VOLVO D13 ENGINE – EGR VALVE STUCK ISSUE

Prevost vehicles

Special Bulletin

SP12-23

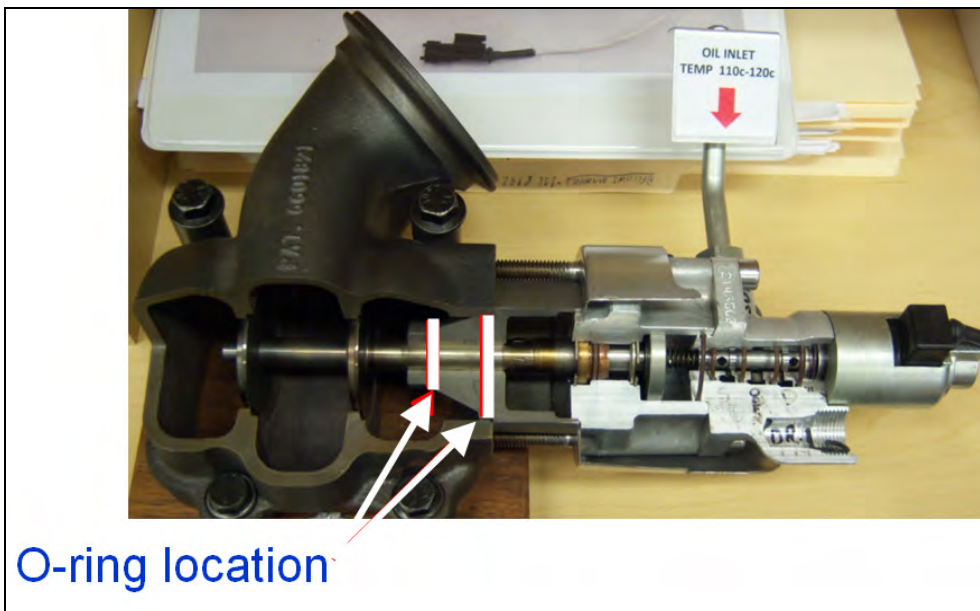
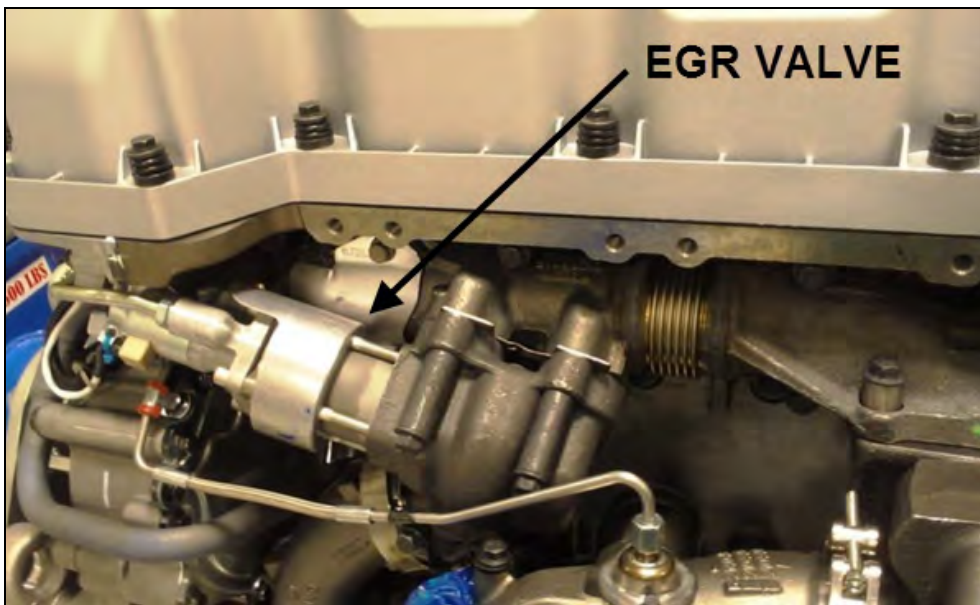
BEFORE UNDERTAKING ANY CORRECTIVE MEASURES, YOU MUST CHECK FIRST THAT THE PRESENT EGR VALVE IS REALLY INVOLVED. CHECK THE PART NUMBER AND DATE CODE ON THE EGR VALVE BODY (refer to the table of involved EGR valve below).

VOLVO PART NUMBER	DATE CODE OF AFFECTED EGR VALVE	
1	21735861	from 086M to162M incl.	
2	21735862		
3	21735863		
4	21735864

The EGR valve can be replaced with the latest version, not equipped with O-rings. A second corrective measure consisting in having the engine running at high power rating on a dynamometer (DYNO test) for a definite period of time. Doing this will burn off the faulty O-rings and get rid of them in an effective way.

NEW COOLANT SURGE COOLANT SURGE TANK ARRANGEMENT

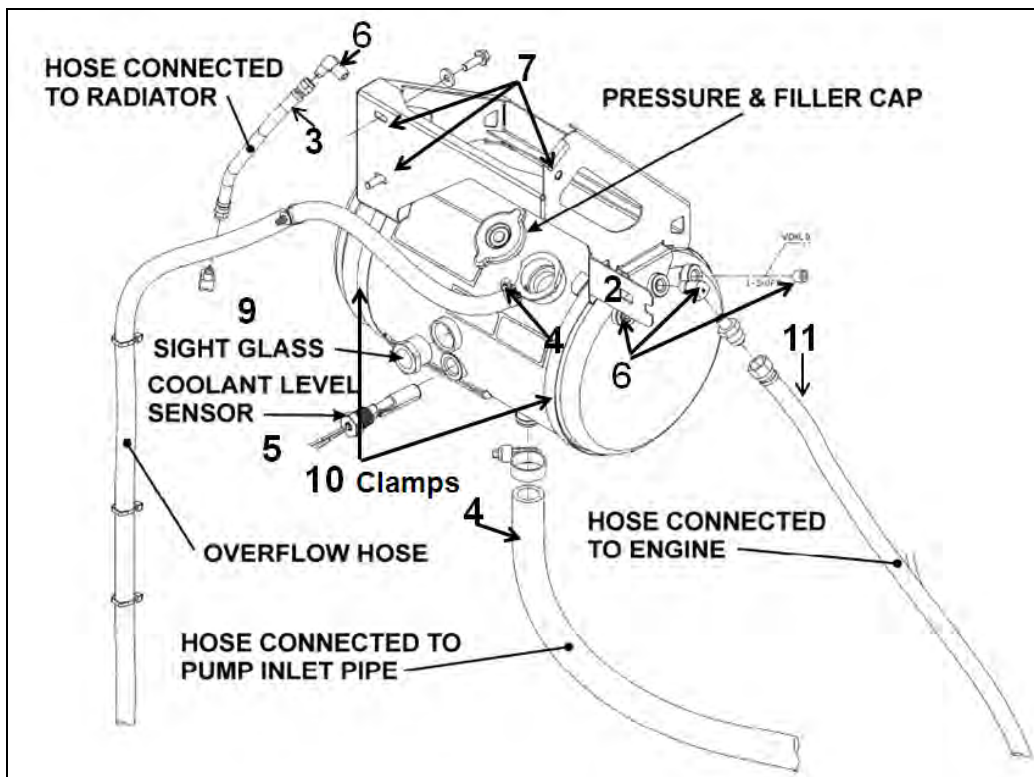
On the vehicles affected by this bulletin, an improved coolant surge tank is available. This new surge tank offers a greater quantity of coolant between the low level sensor and the middle of sight glass level (5.2 quarts instead of 2.3 quarts). You will benefit from less frequent low coolant alarms.

1. Cut the tie wrap holding the DEF lines to the coolant surge tank bracket.
2. Disconnect each hose connected to the coolant surge tank.
3. Place a clean rubber tube into the coolant surge tank. Using siphon effect, drain coolant surge tank.
4. Remove tie wraps and unplug low level sensor connector (5).
5. Loosen all fittings and sight glass.
6. Remove 3 bracket bolts (7) and remove coolant surge tank and bracket. Pull the coolant surge tank through the SCR converter.
7. Turn the tank in order to have the level sensor at the top, in a vertical position and then unscrew it from the coolant surge tank.
8. Remove sight glass and all fittings from coolant surge tank.
9. Loosen band clamps (10) and separate coolant surge tank from bracket. Return to Prevost for full reimbursement.
